Meeting Agenda Plat Committee

Monday, November 14, 2022

1. [KPB-4734](#) ASLS No. 2021-37 North Fork Micro AG Subdivision; KPB File 2022-158

ALASKA STATE LAND SURVEY NO. 2021-37
 NCRT FORK MICRO AG SUBDIVISION

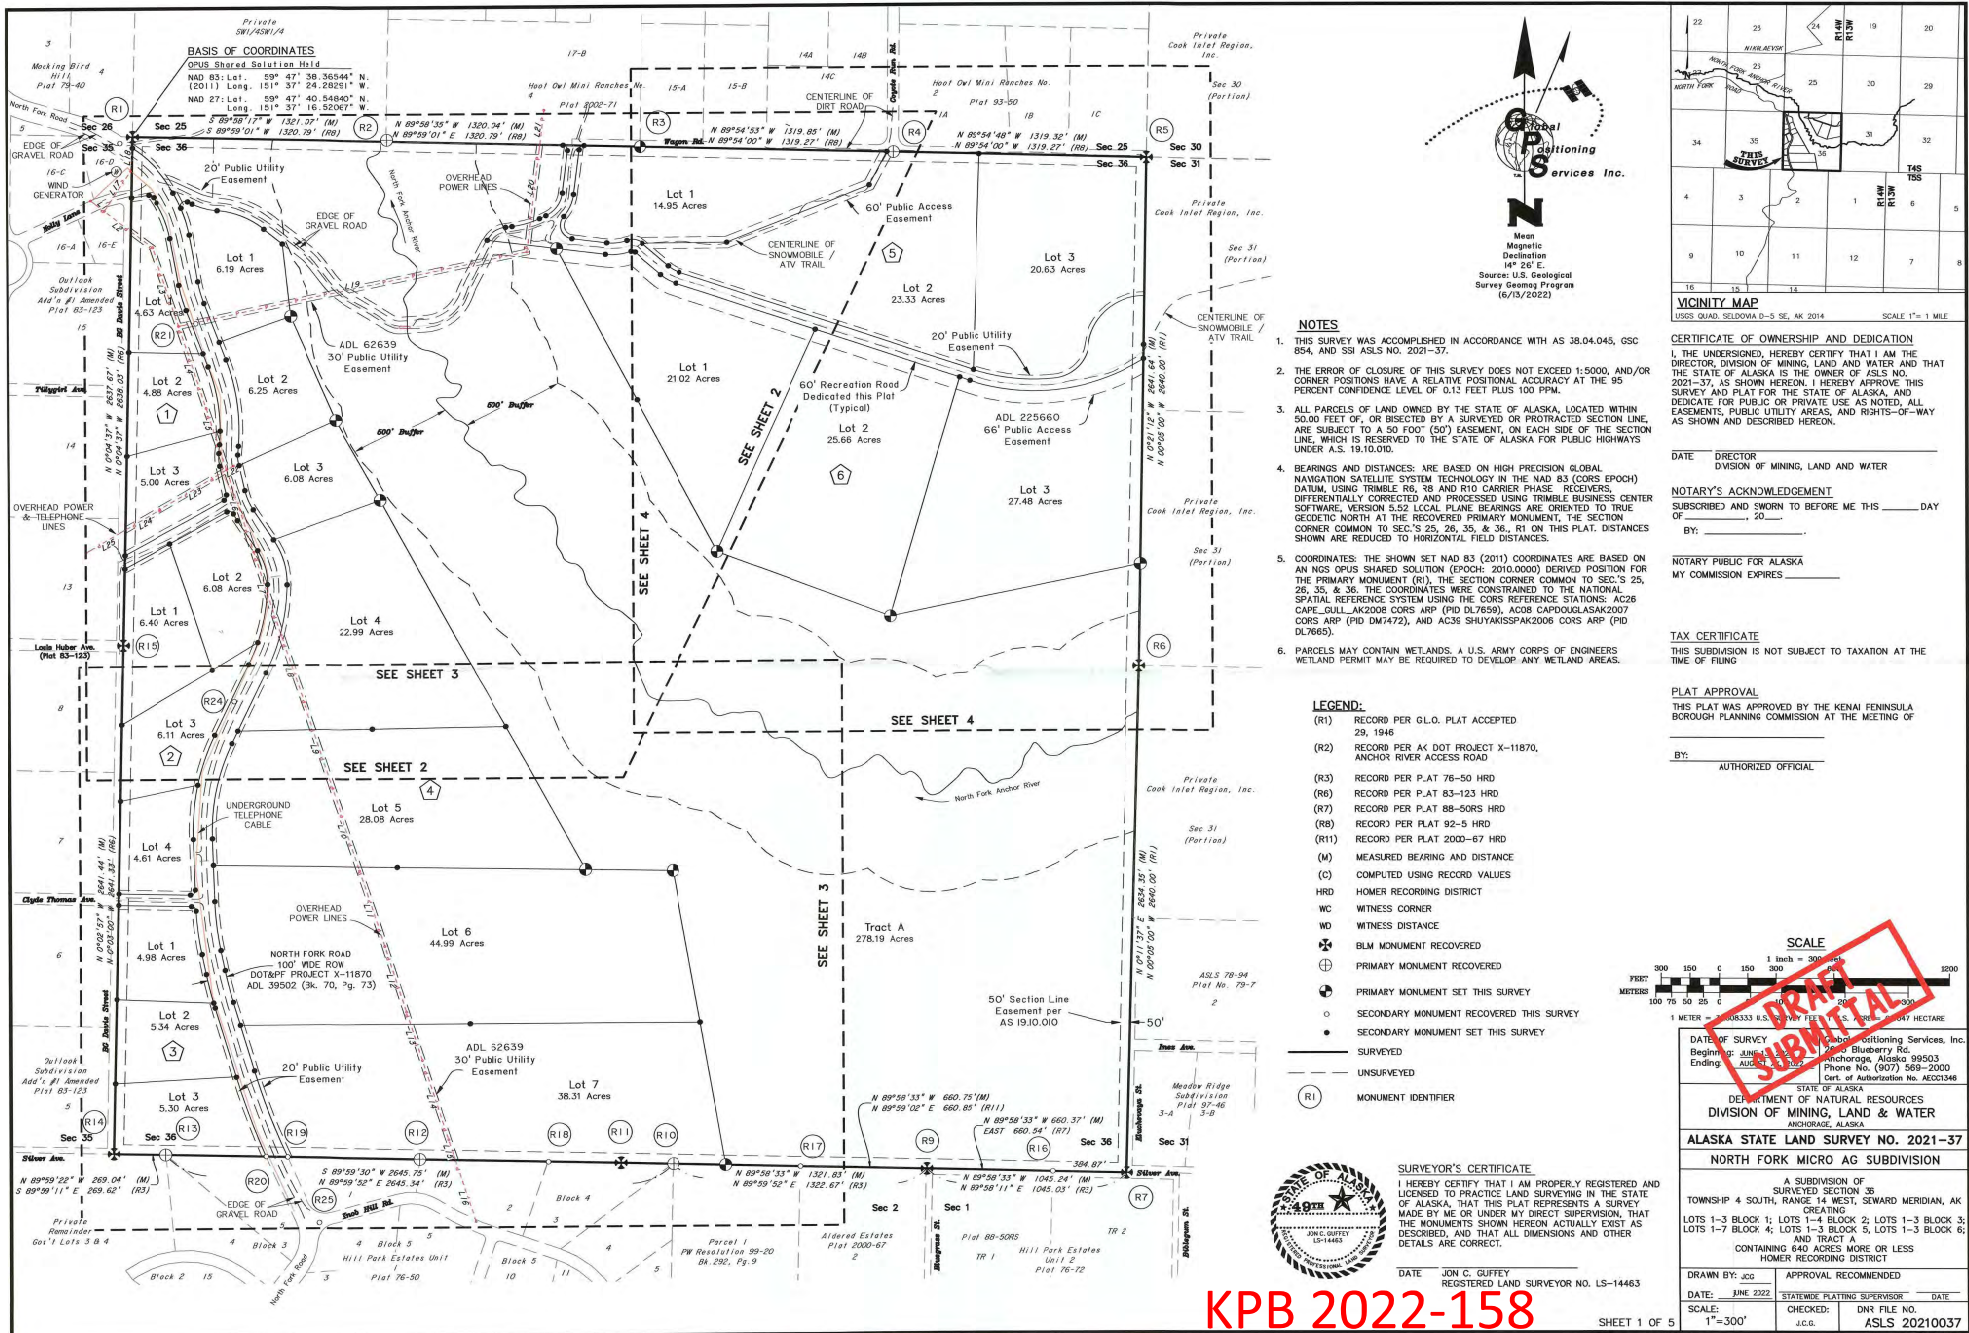
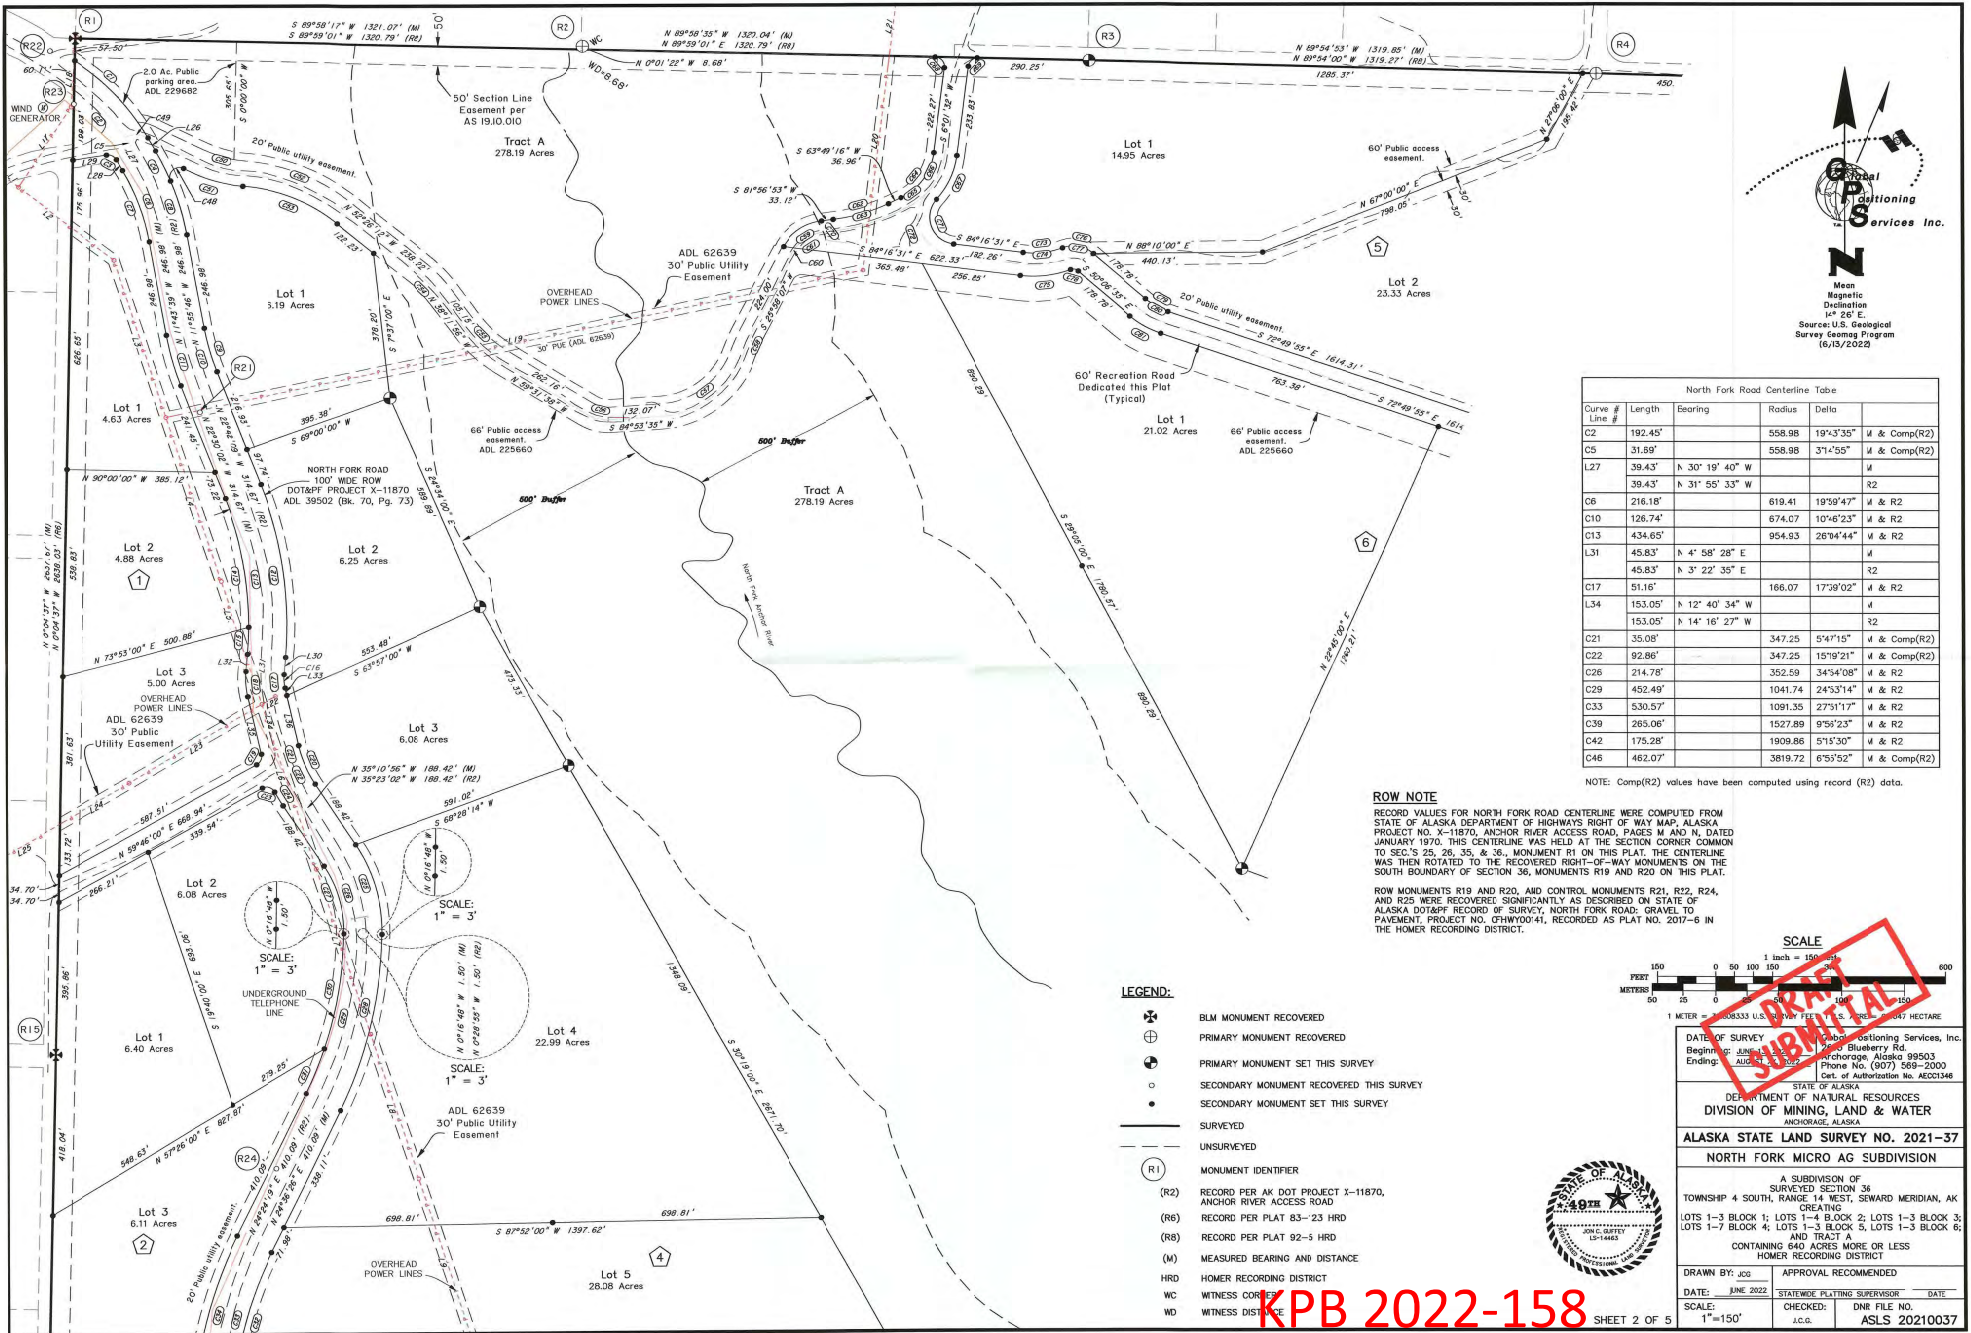
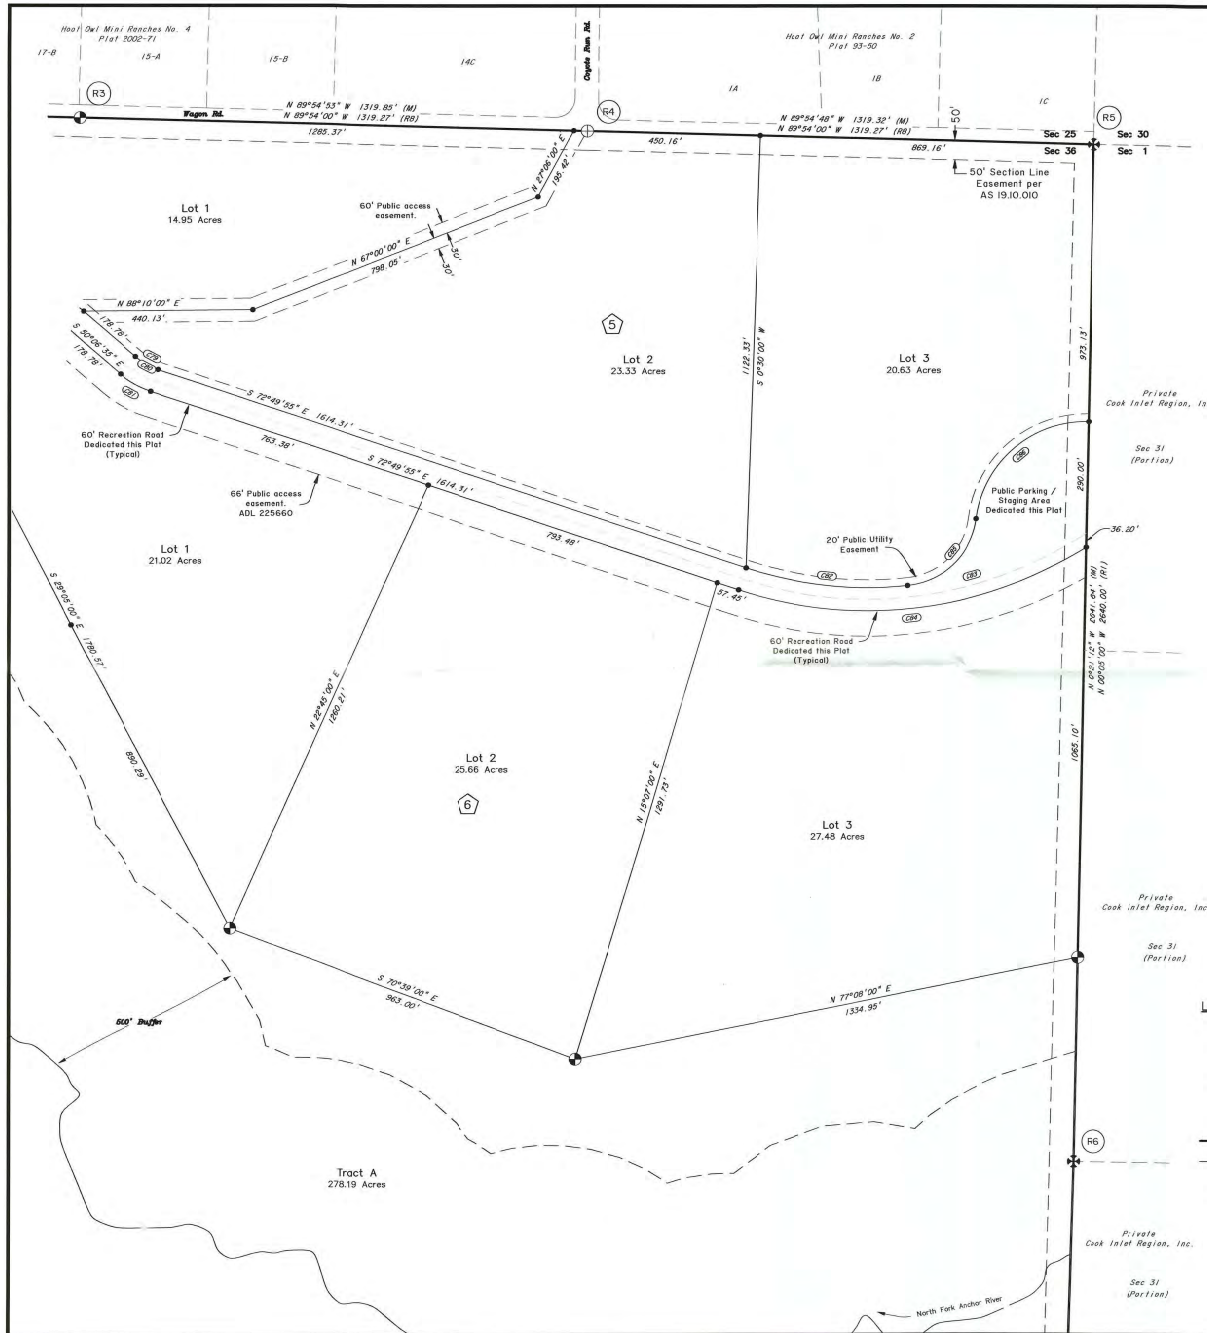
Section line easements exist around the perimeter of the subdivision and have some labeling. ***Staff recommends a different line style be used to depict the section line easements so minimal labels can remain but the legend will clarify the status of the line shown.***

KPB Code requires minimum 10 foot utility easements adjacent to rights-of-way. Staff is requesting additional dedications to provide for matching dedications. **Staff recommends 10 foot utility easements adjacent to all dedications within the subdivision with a required plat note, if depiction is not possible, a typical detail depiction may be used.**

The preliminary plat was submitted as a 4 page document. Unless a 5th page is going to be added at final, update all pages to state of 4 sheets.

Staff recommendation: *The mailing address for the owner is required. Within the information for the subdivision, Kenai Peninsula Borough and State of Alaska should be added to the location information. The KPB File number of 2022-158 should be added in or near the title block.*

Staff recommendation: *Plat note is needed and depiction must be provided. If unable to depict a typical depiction detail may be used.*

Staff recommendation: Acceptance for rights-of-way will be required. The notary shown is a combination of Acknowledgement and jurat. Remove "sworn" or change to Notary's Jurat. Comply with 20.60.190.
